ADDENDUM

PROJECT: University of South Dakota
Verizon Transformer
Vermillion, South Dakota

AD-1

DATE ISSUED: Wednesday, July 16, 2014

Issue Date	07-15-2014
Job #	14-0119
Drawn by:	JEP
CADD file:	E-101.dwg
COPYRIGHT © DAVIS DESIGN ALL RIGHTS RESERVED	
Drawing Title Electrical Site Plan	
From Sheet:	for CA use:
E-101	
Drawing #	
E-101.1

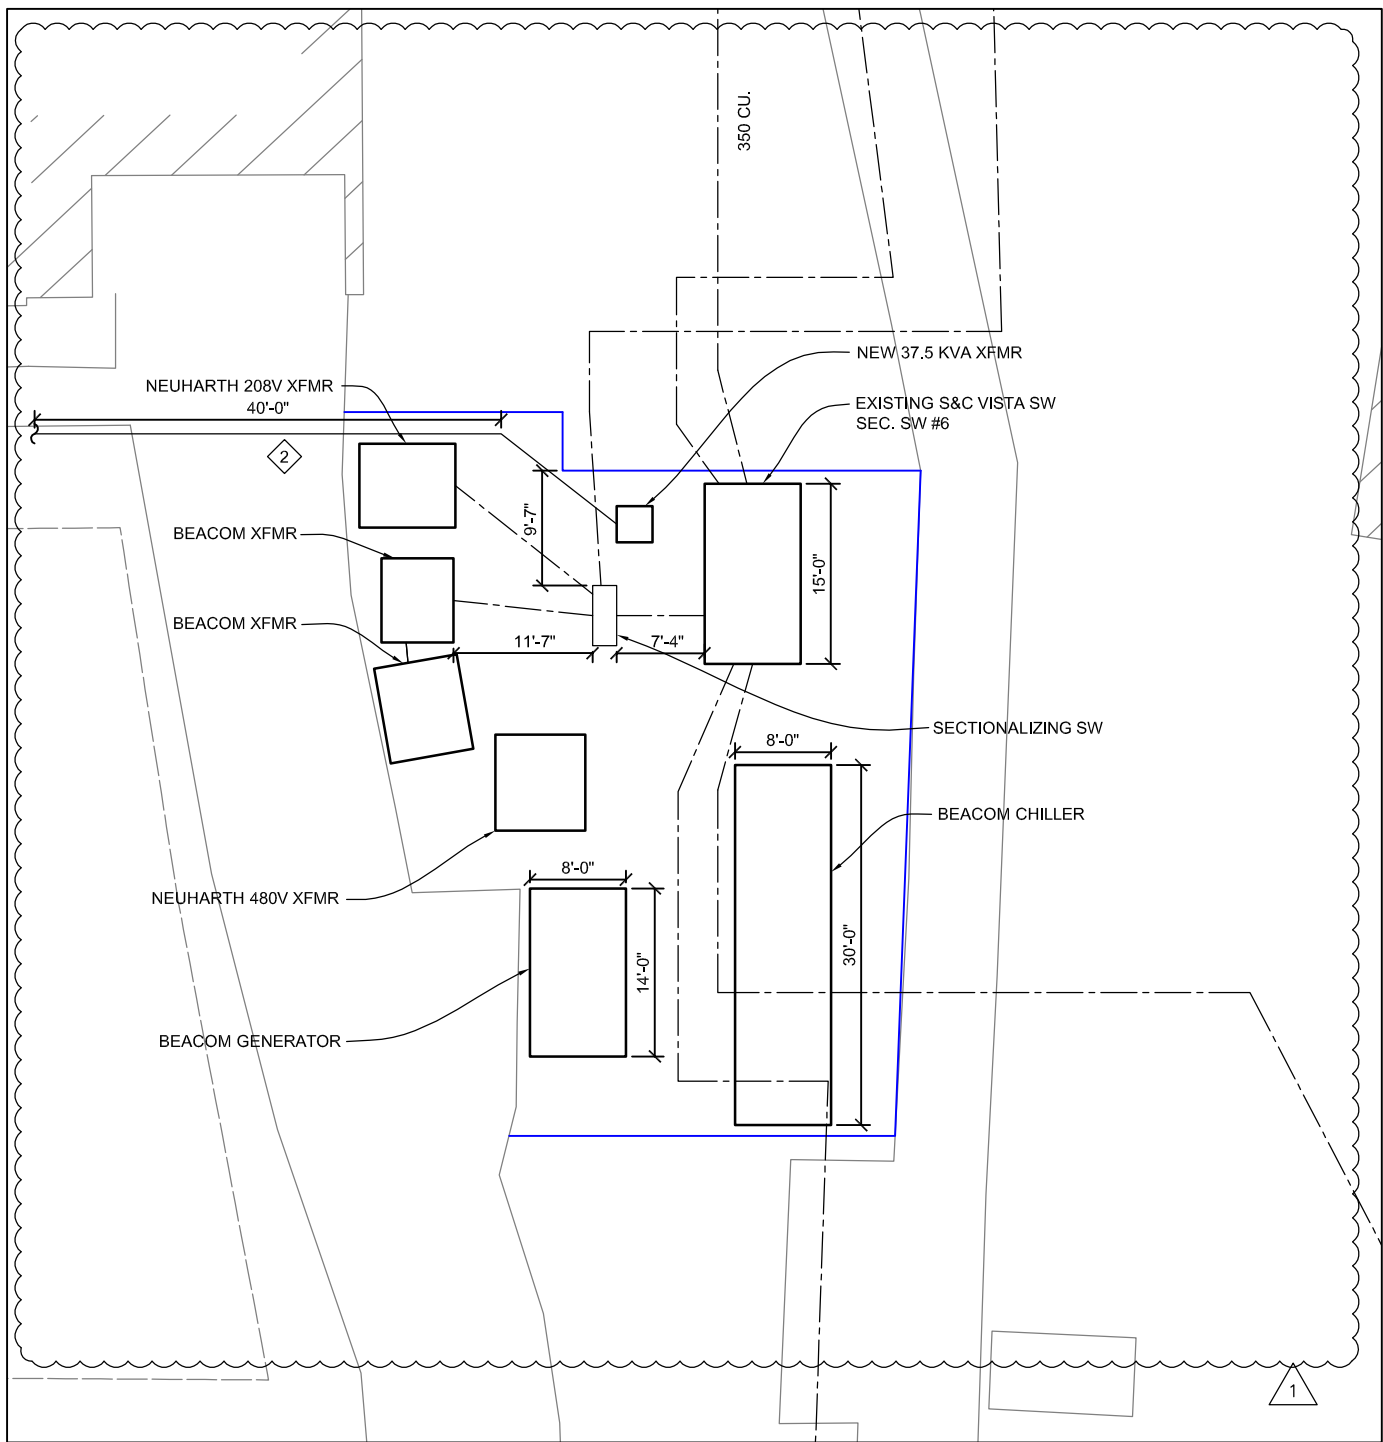
In reference to Sheet E-101, Electrical Site Plan is not to scale. See attached E-101.1 for approximate distances. Also, refer to specification 26 01 00 1.2A for Site Visitation requirement.

TYPICAL PAD MOUNTED TRANSFORMER GROUNDING DETAIL

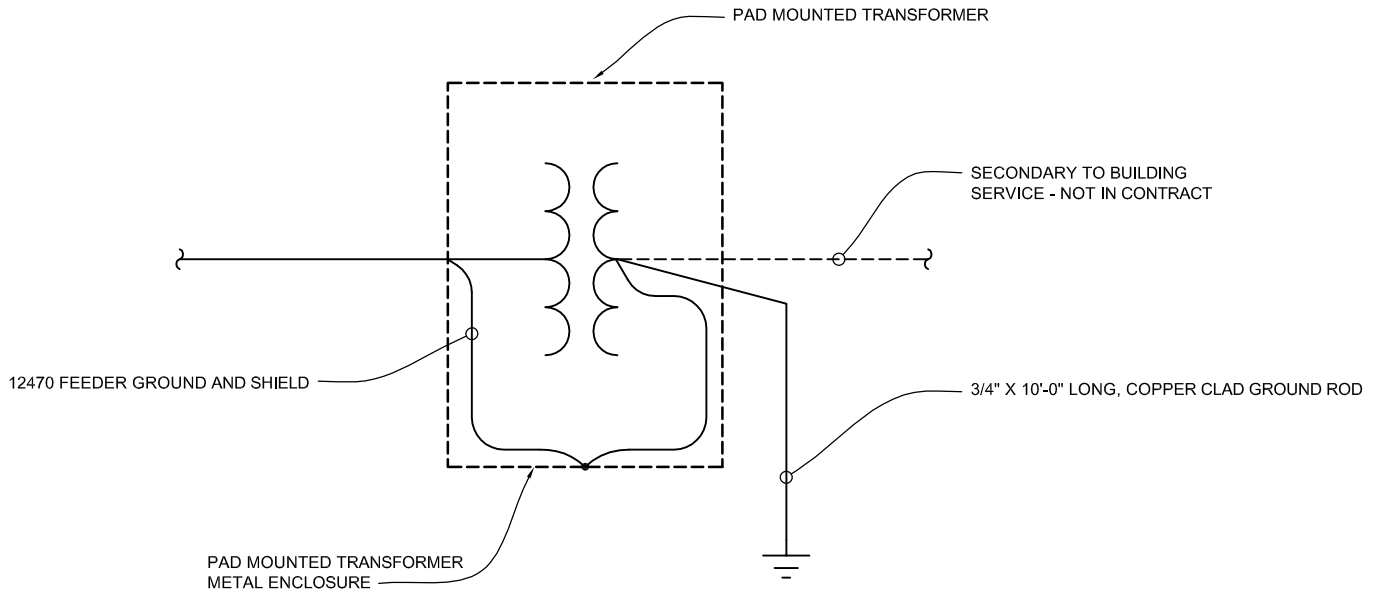
In reference to Sheet E-101, see attached E-101.2 for transformer grounding detail.
